Serial No.: 15-245A  
NLOS/DEA: R1  
Docket No.: 50-338  
License No.: NPF-4

**VIRGINIA ELECTRIC AND POWER COMPANY (DOMINION)**  
**NORTH ANNA POWER STATION UNIT 1**  
**RESPONSE TO REQUEST FOR ADDITIONAL INFORMATION**  
**PROPOSED INSERVICE INSPECTION ALTERNATIVE N1-I4-SPT-006**

**Virginia Electric and Power Company  
(Dominion)  
North Anna Power Station Unit 1**

**DRAWING 11715-CBM-095C-4, Sheet 1 of 2  
ISI CLASSIFICATION BOUNDARY DWG INTERVAL-4  
CHEMICAL AND VOLUME CONTROL SYSTEM  
NORTH ANNA POWER STATION UNIT 1**

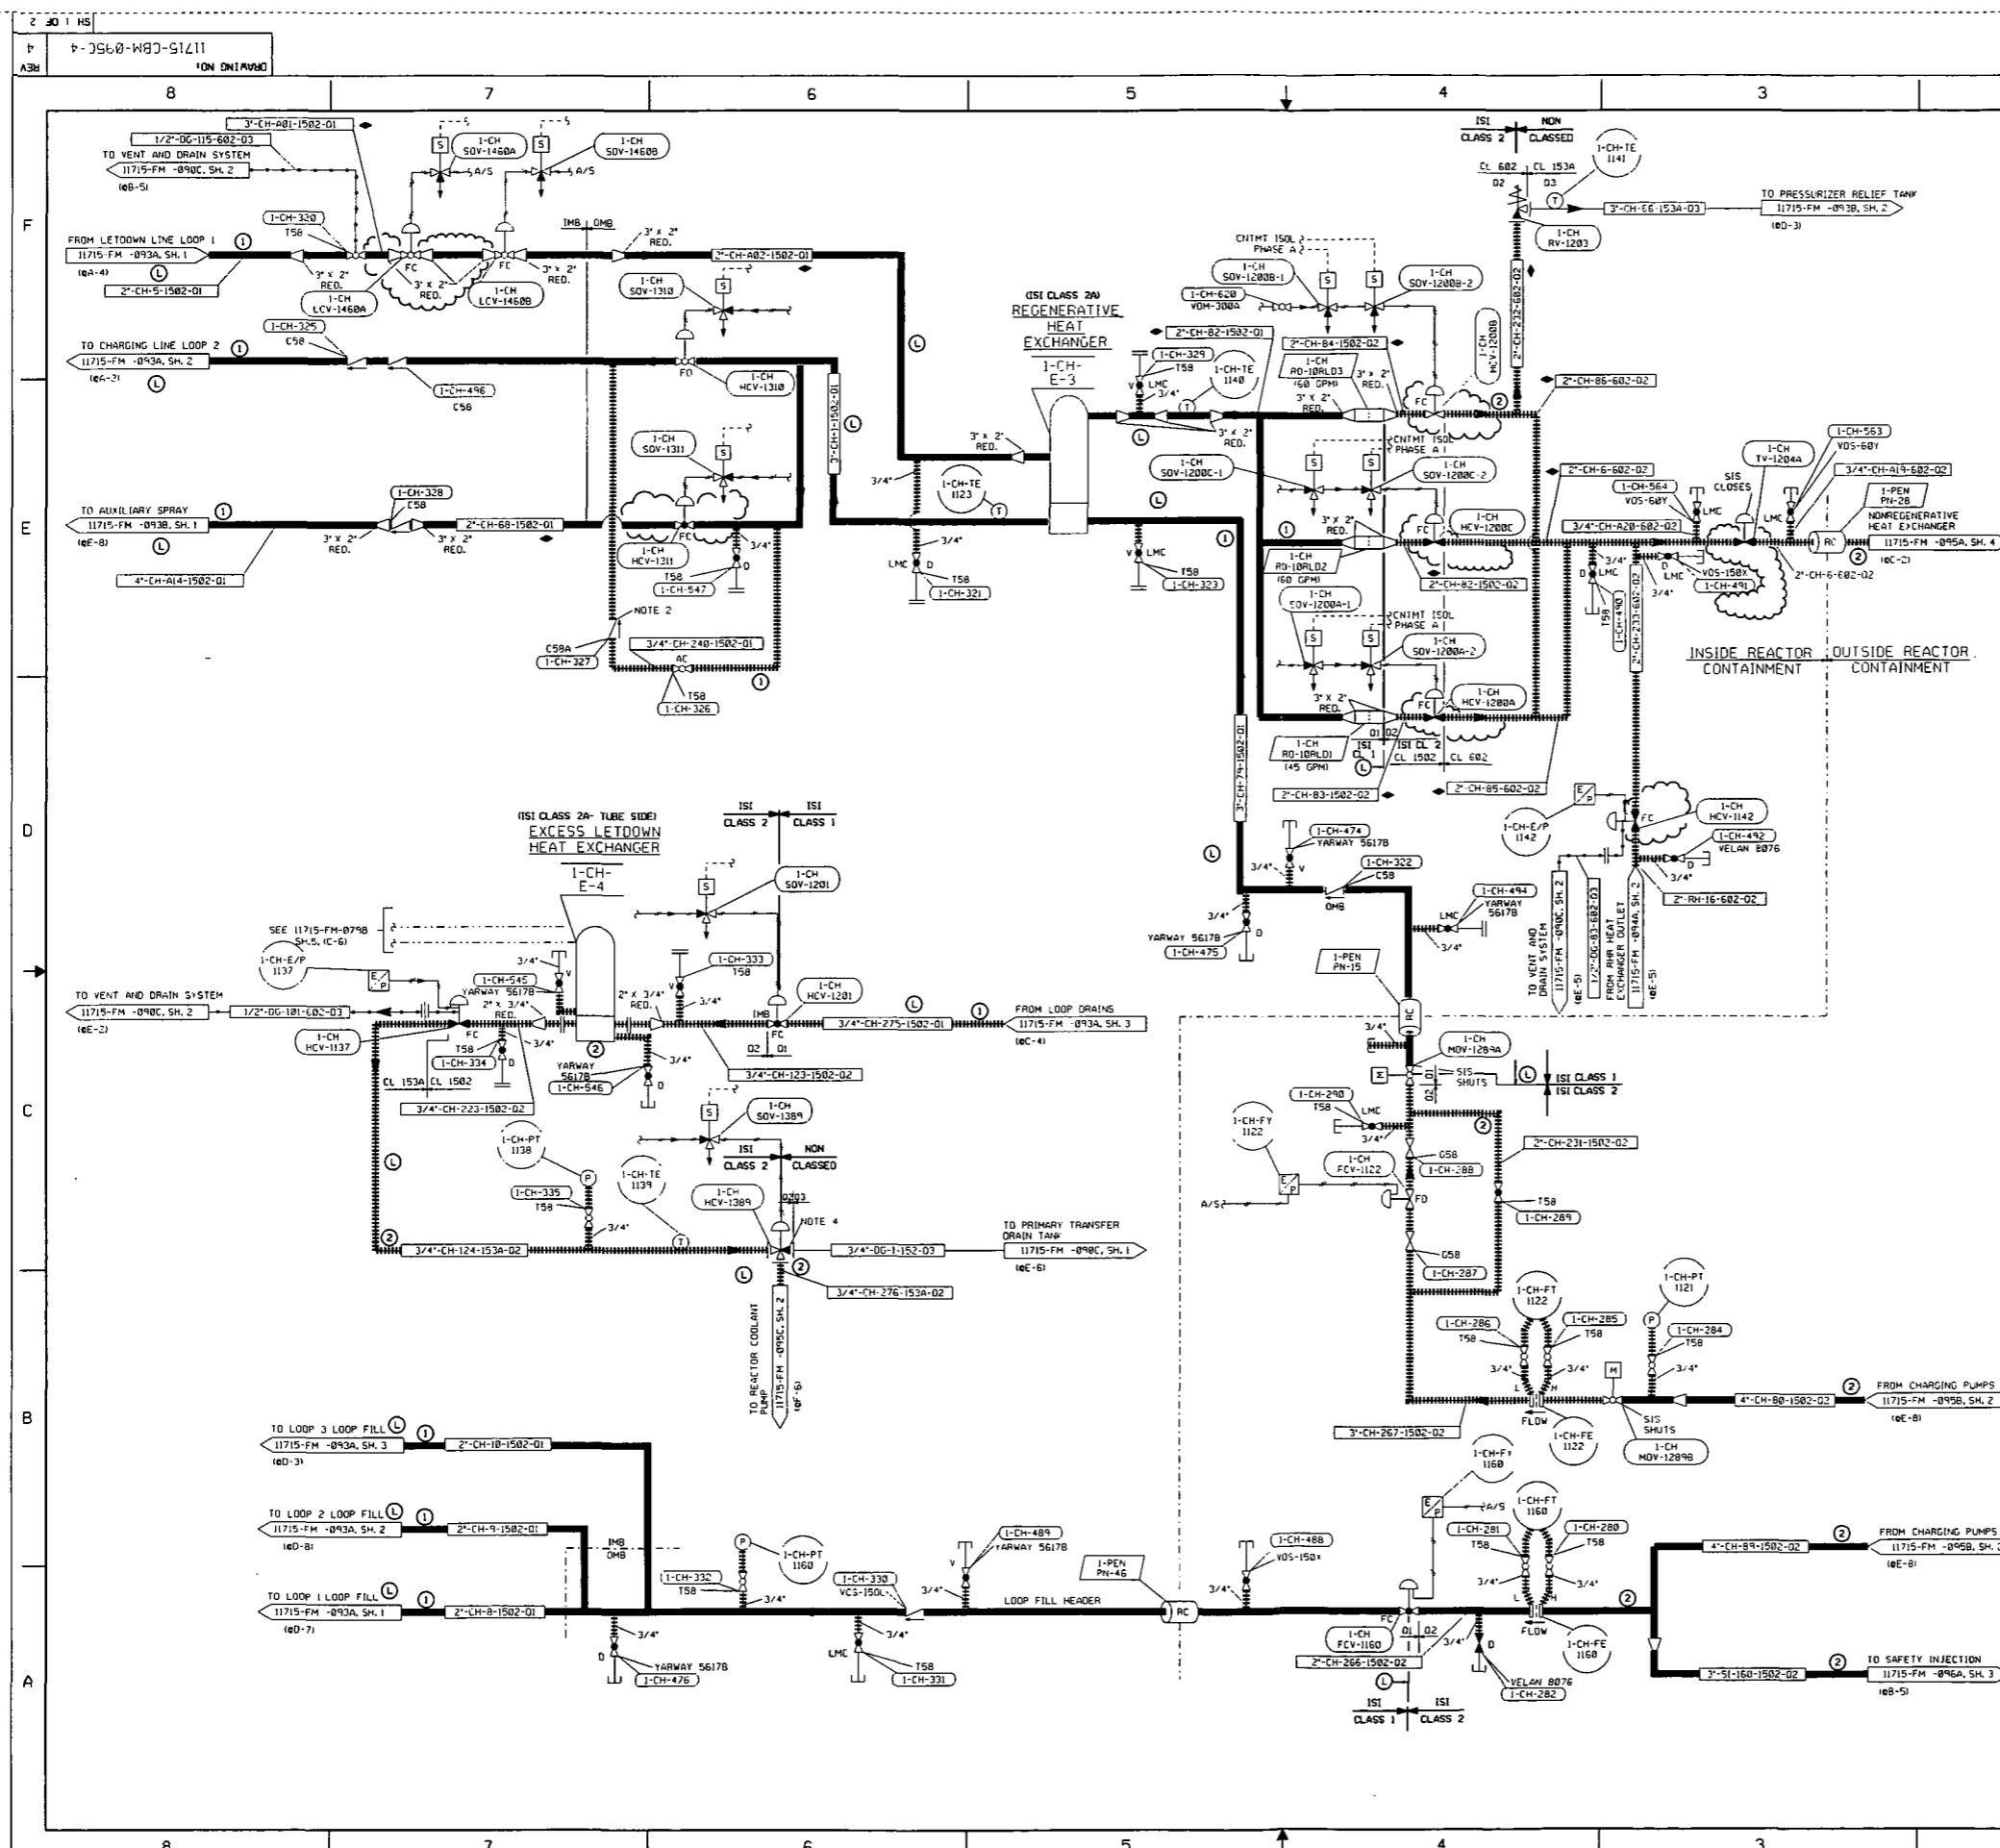
Please provide a drawing of the auxiliary spray piping segment. The drawing is listed on the Relief Request as 11715-CBM-095C-4, Sheet 1 of 2, but was not included with the request.

A copy of drawing 11715-CBM-095C-4, Sheet 1 of 2, ISI Classification Boundary Dwg Interval-4, Chemical and Volume Control System, North Anna Power Station Unit 1, is included as Attachment 2.
